**SOLICITATION AMENDMENT
MODIFICATION DE L'INVITATION**

Title - Sujet CEF BLDG 54 Envelope Conservation	
Solicitation No. - N° de l'invitation EP076-162305/A	Amendment No. - N° modif. 004
Client Reference No. - N° de référence du client 20162305	Date 2016-05-20
GETS Reference No. - N° de référence de SEAG PW-\$\$\$FG-358-70840	
File No. - N° de dossier fg358.EP076-162305	CCC No./N° CCC - FMS No./N° VME
Solicitation Closes - L'invitation prend fin at - à 02:00 PM on - le 2016-05-31	Time Zone Fuseau horaire Eastern Daylight Saving Time EDT
F.O.B. - F.A.B. Plant-Usine: <input type="checkbox"/> Destination: <input type="checkbox"/> Other-Autre: <input type="checkbox"/>	
Address Enquiries to: - Adresser toutes questions à: Michaud, Jasmin	Buyer Id - Id de l'acheteur fg358
Telephone No. - N° de téléphone (873) 469-4920 ()	FAX No. - N° de FAX (819) 956-8335
Destination - of Goods, Services, and Construction: Destination - des biens, services et construction:

INTRODUCE ADDENDUM #01.

BUILDING ENVELOPE CONSERVATION

A
A-101
BASEMENT PLAN
1:75
DEMOLITION

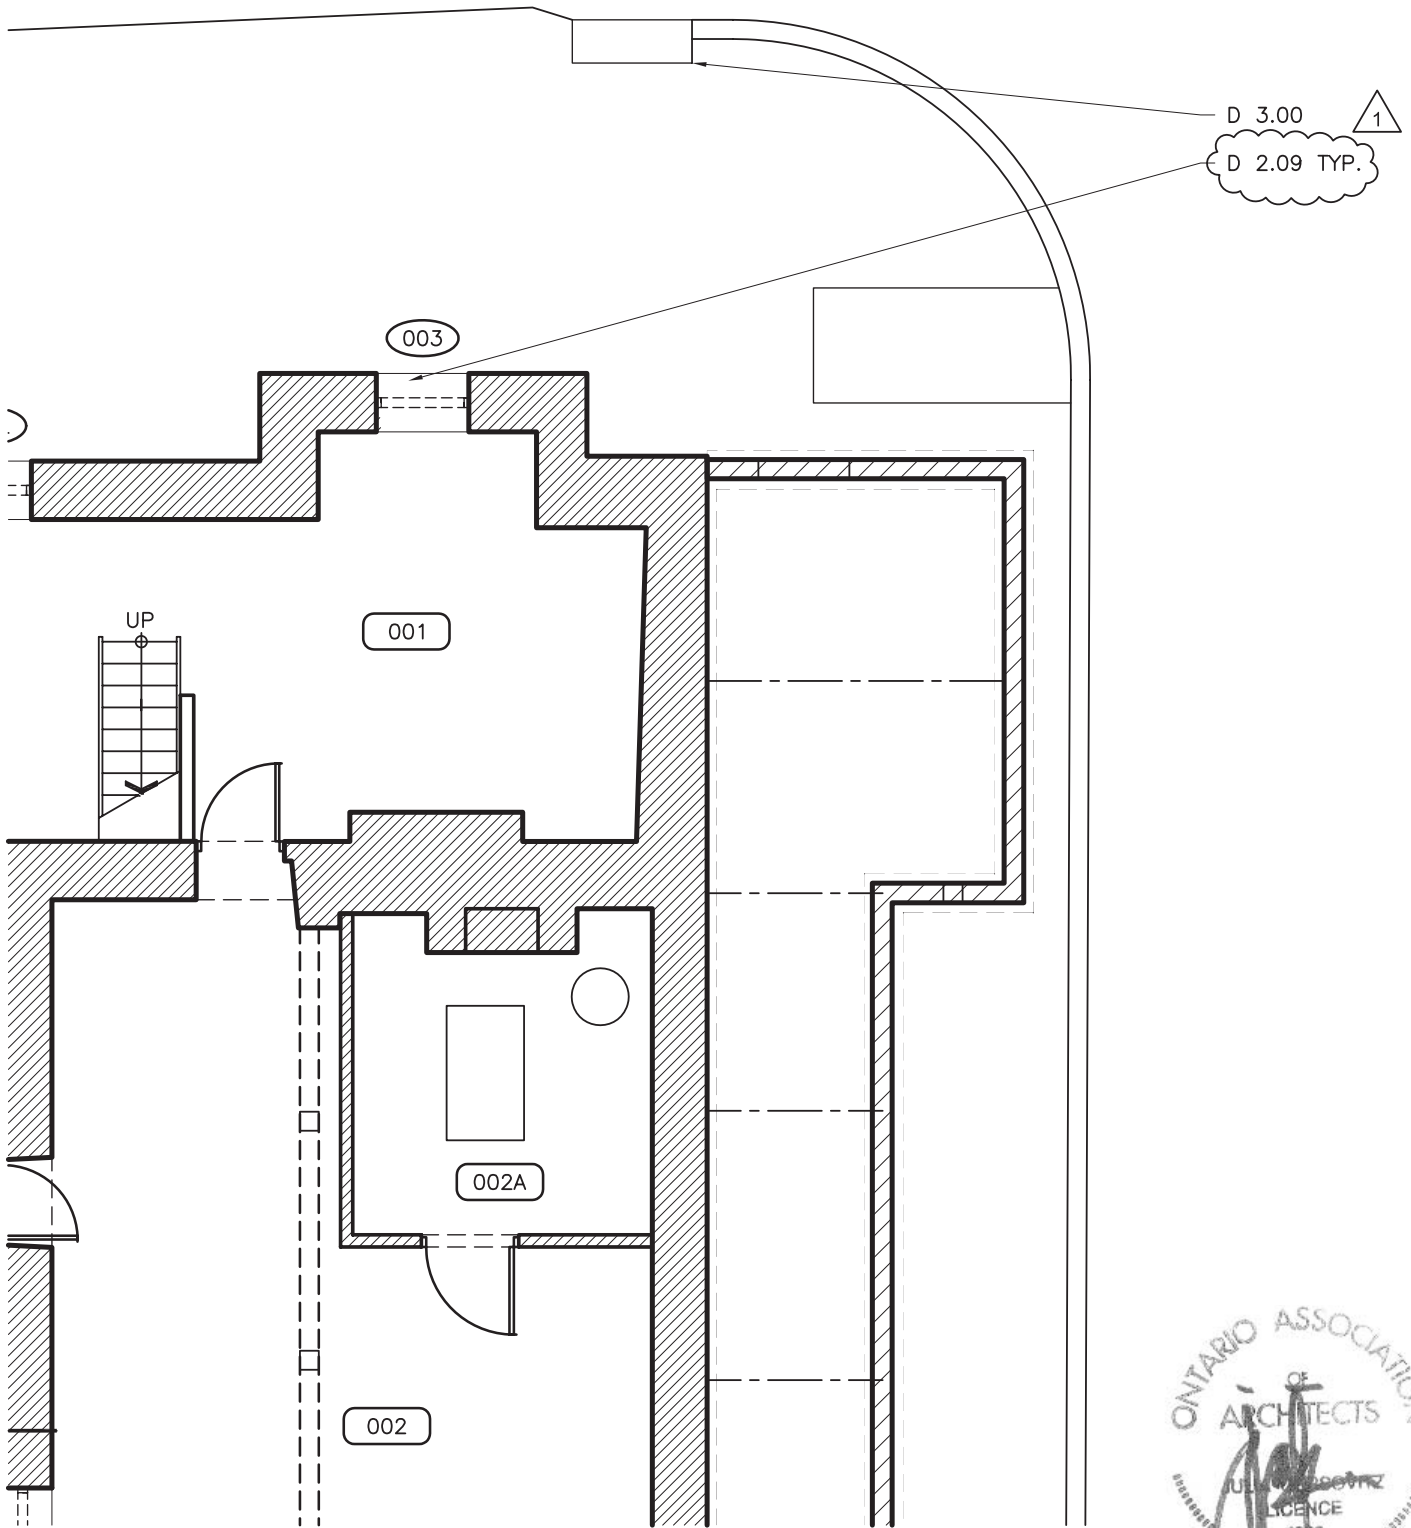
1. A-101 to A-105 and A-301 to A-304: DELETE construction note 4.01.
2. A-101 Detail A: REPLACE note as identified in sketch ASK-01.
3. A-303 Detail B: REPLACE note as identified in sketch ASK-02.
4. A-402
 - .1 Detail 1B: REPLACE reference as identified in sketch ASK-04.
 - .2 Detail 2B: REPLACE note as identified in sketch ASK-04
5. A-502 Windows Schedule, Door Schedule and Legend: REPLACE text as identified in sketch ASK-03.
